Re: Grassy Pond Place Definitive Subdivision  
James D'Agostine  
6673

The purpose of this letter is to request that the Commission permit as a "red-line revision" the elimination of the retaining wall on the left hand side of Grassy Pond place and allow its replacement with a 3 horizontal to 1 vertical retaining wall.

Re: Grassy Pond Place Definitive Subdivision  
James D'Agostine  
6673

## RETAINING WALL DETAILS - N.T.S

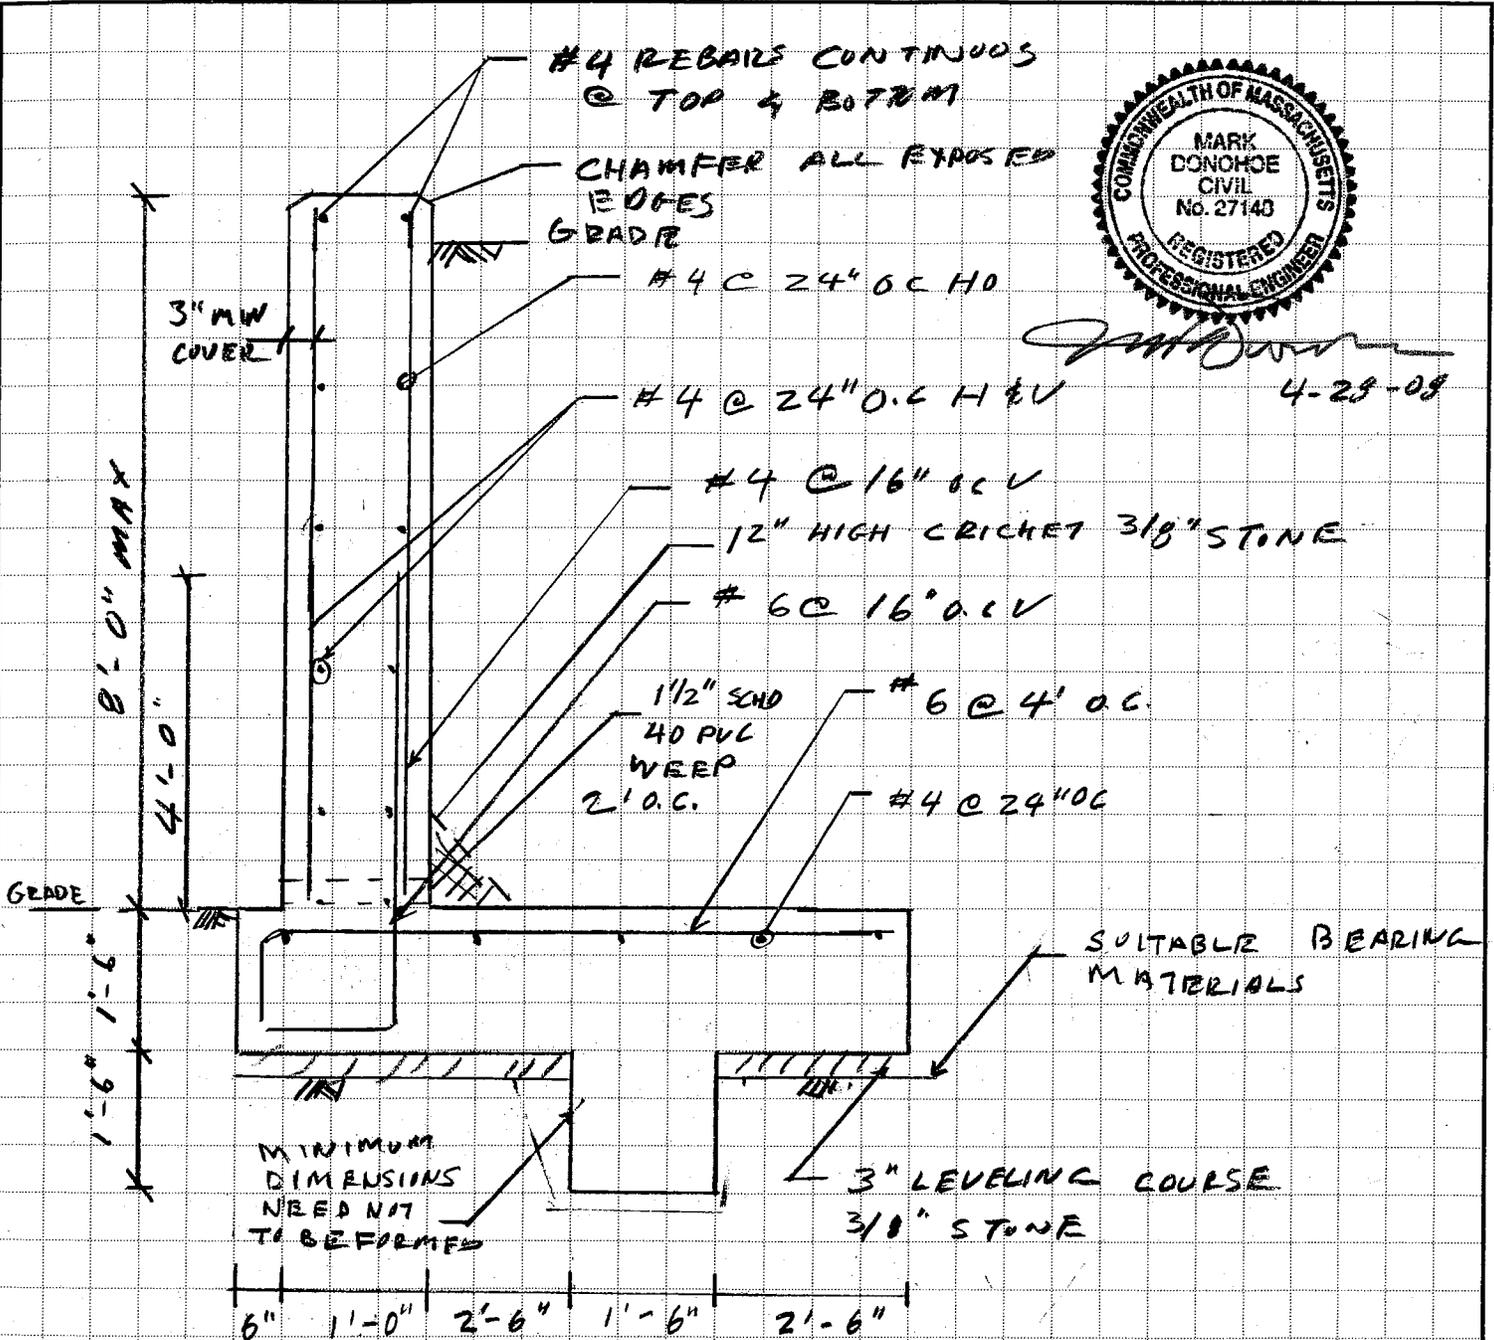
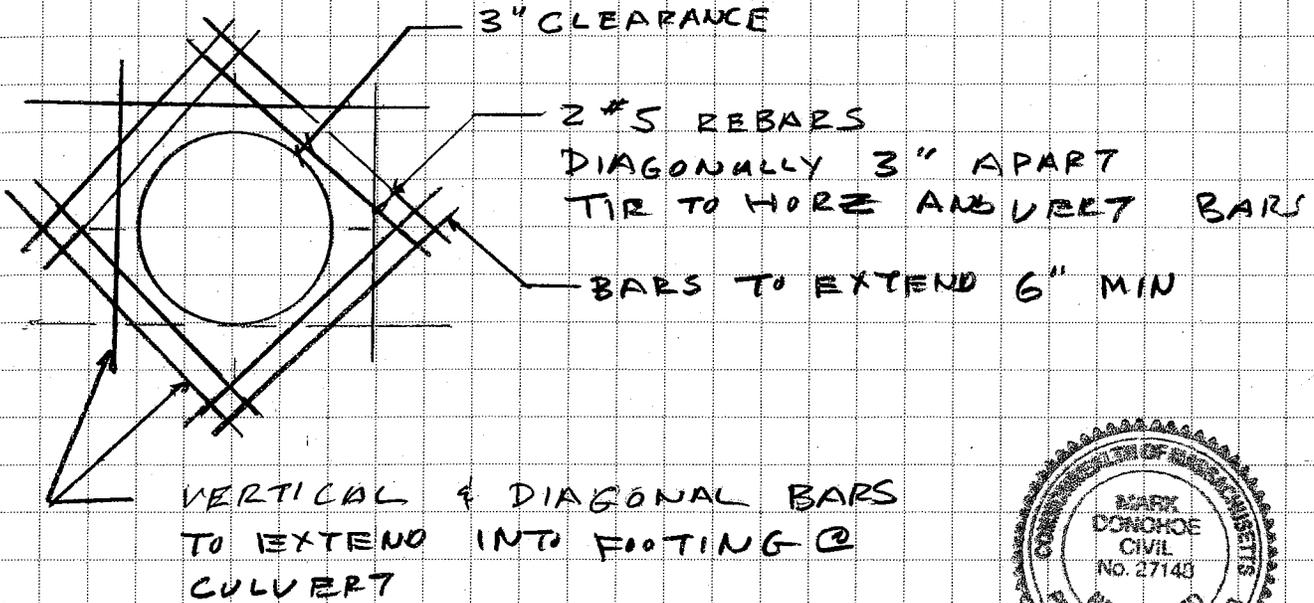
The purpose of this letter is to request that the Board permit as a "red-line revision" the elimination of the retaining wall on the left hand side of grassy Pond place and allow its replacement with a 3 horizontal to 1 vertical retaining wall.

We believe that this revision should be allowed as the installation of retaining walls on both sides of the road will result in deeper frost penetration; result in construction difficulties for the installation of the catch basins, increase construction costs and is unnecessary.

The approved plans did not include details pertaining to the construction requirements for the proposed wall and we have designed the wall on the attached sheets to serve this purpose.
